PRODUCT INFORMATION BULLETIN

Date: October 30, 2014
Number: 8170
Division: Genie®
Product Family: Residential Openers
Product Series: ReliaG® Series, Models 2028 & 1028
To: All Genie Professional Line Wholesalers, Dealers and Installers
Re: “Humming” Transformer

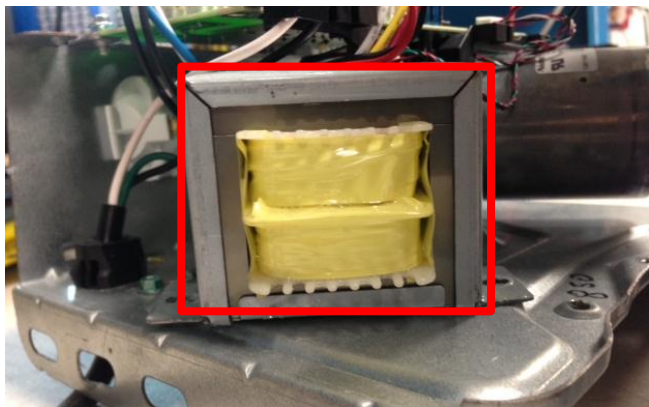
During examination of our Technical Services call history for the month of June, some reports were identified regarding a “humming” noise coming from random Models 2028 & 1028 units in the field. In early July, inspection began on 100% of these items coming down the manufacturing line. Our investigation identified defects in the transformer manufacturing process as the source of the humming. While most of the affected transformers were screened at the manufacturing plant, some of the transformers had latent defects that were not detectable at the time of inspection and have manifested in the field. We have taken corrective action at the transformer manufacturer and have returned the product to normal performance.

The first 5 digits of the serial numbers of possibly affected units are as early as 14121 and no later than 14233. As of August 21st (14233), the issue was resolved completely.

Part Number: ~~38646R.S~~

Epoxied, Stacked Lamination 120V
Transformer for Models 2028 & 1028

If you encounter a “humming” transformer in one of these units, we recommend that you replace the transformer.
